FILE NUMBER: Z201-332(KC) **DATE FILED:** August 2, 2021**LOCATION:** Southwest corner of North Riverfront Boulevard and Cole Street.**COUNCIL DISTRICT:** 6 **MAPSCO:** 44 H**SIZE OF REQUEST:** Approx. 1.62 acres **CENSUS TRACT:** 0100.00

REPRESENTATIVE: Jackson Walker LP (Bill Dahlstrom)**APPLICANT:** Bird's Opening, LLC**OWNER:** Ewing Properties, LLC**REQUEST:** An application for 1) a new subdistrict; and 2) a Specific Use Permit for Indoor Athletic and Entertainment Center use on property zoned Subdistrict 1A within Planned Development District No. 621, the Old Trinity and Design District.**SUMMARY:** The purpose of the request is to reduce the required parking and require an SUP for the proposed Indoor Athletic, and Entertainment Center use and for an SUP to allow for the Indoor Athletic and Entertainment Center.**CPC RECOMMENDATION:** **Approval** of the new subdistrict, subject to a revised development plan, a landscape plan, and conditions; and **approval** of the Specific Use Permit for a seven-year period, subject to a revised site plan and revised recommended conditions.**STAFF RECOMMENDATION:** **Approval** of the new subdistrict, subject to a development plan, a land

CPC RECOMMENDED DEVELOPMENT PLAN

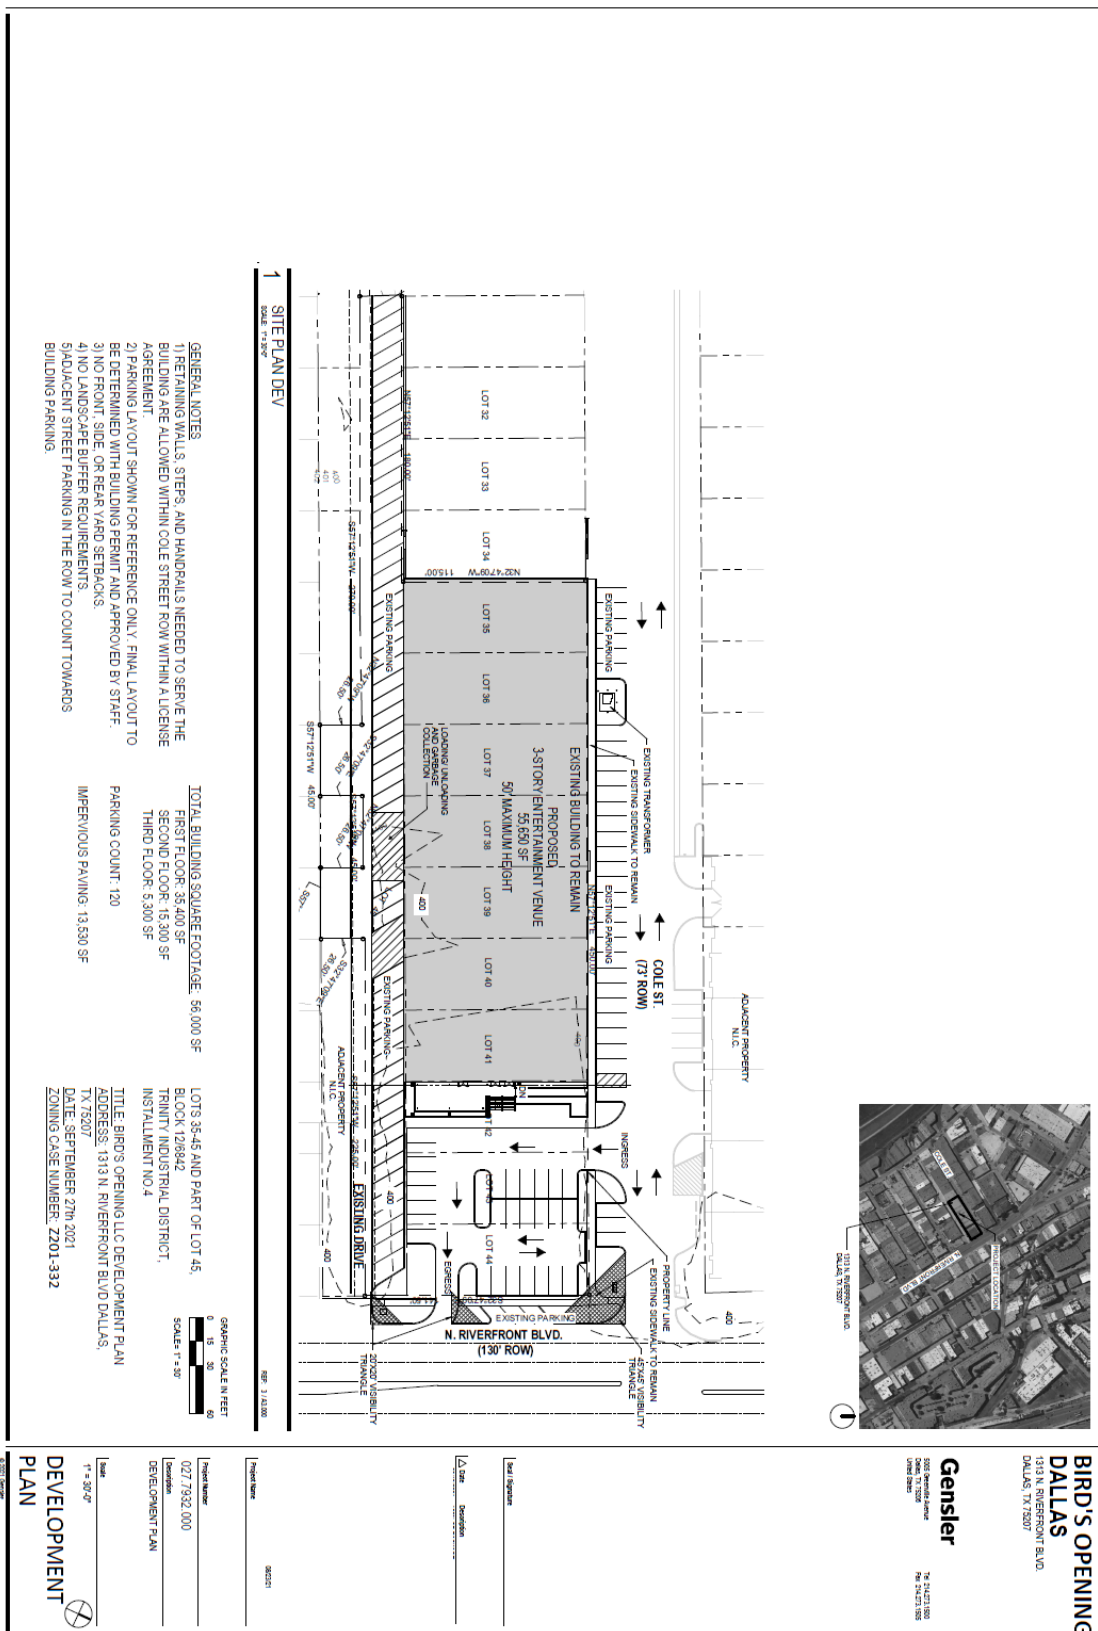
Staff still recommends approval of the proposed development plan and SUP site plan **subject to** the following revisions:

- Plans must comply with ADA sidewalk requirements and provide at least 5-ft wide sidewalks while still accommodating adequate space for 18-ft indented head-in parking along Cole.

The proposed conditions allow for this site to not be subject to the site design standards provided in PD 621. Staff does not support the proposed site plan showing the existing sidewalks that are noncompliant to remain. Staff recommends that the site comply with ADA sidewalk requirements and provide at least 5-ft wide sidewalks while still accommodating adequate space for 18-ft indented head-in parking along Cole Street. In addition to the design standards, the conditions allow for the site to not be subject to the screening requirements. Although it is not subject to the requirements, there is still shrubs and street trees provided on the landscape plan to help screen the off-street parking that is being proposed within the parking lot. The landscape plan is providing trees and shrubs

CPC RECOMMENDED LANDSCAPE PLAN

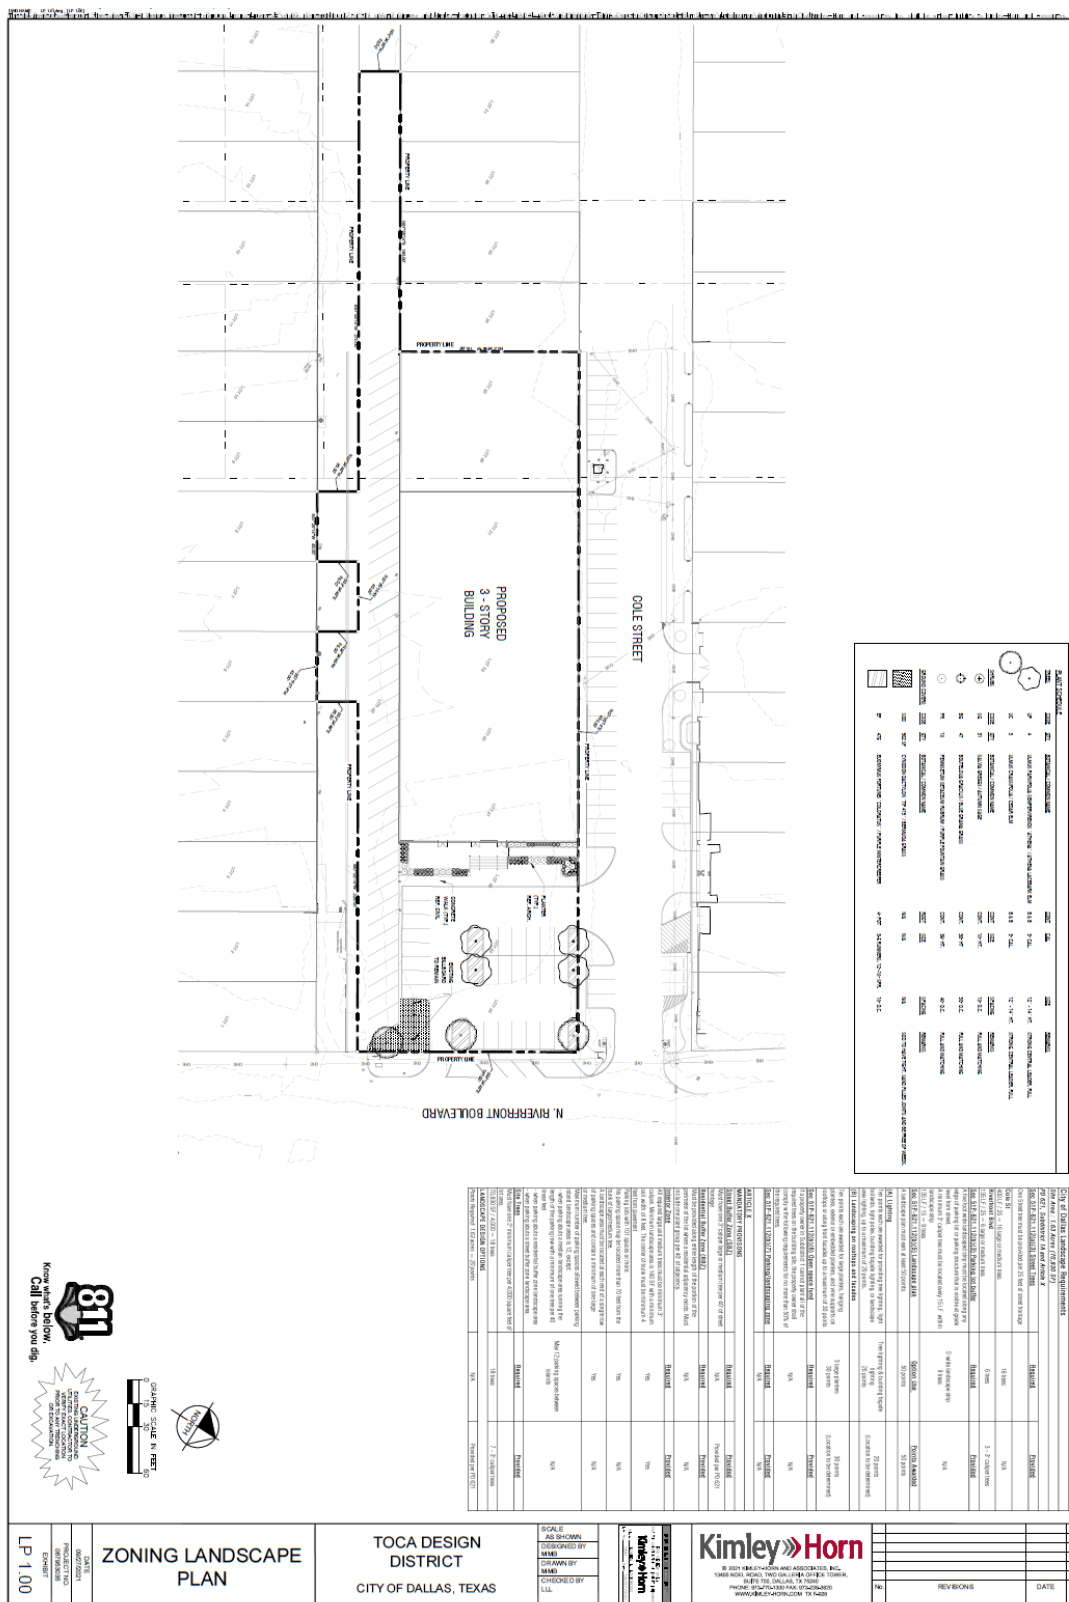
The request includes amending the landscaping requirements to deviate from what is required per the current PD 621 conditions. The landscape plan shows a total of seven trees provided, as opposed to the 18 required. In addition, Cole Street requires 16 street trees along the frontage and Riverfront Boulevard requires six but only two street trees along Cole Street and three street trees along Riverfront Boulevard are provided.
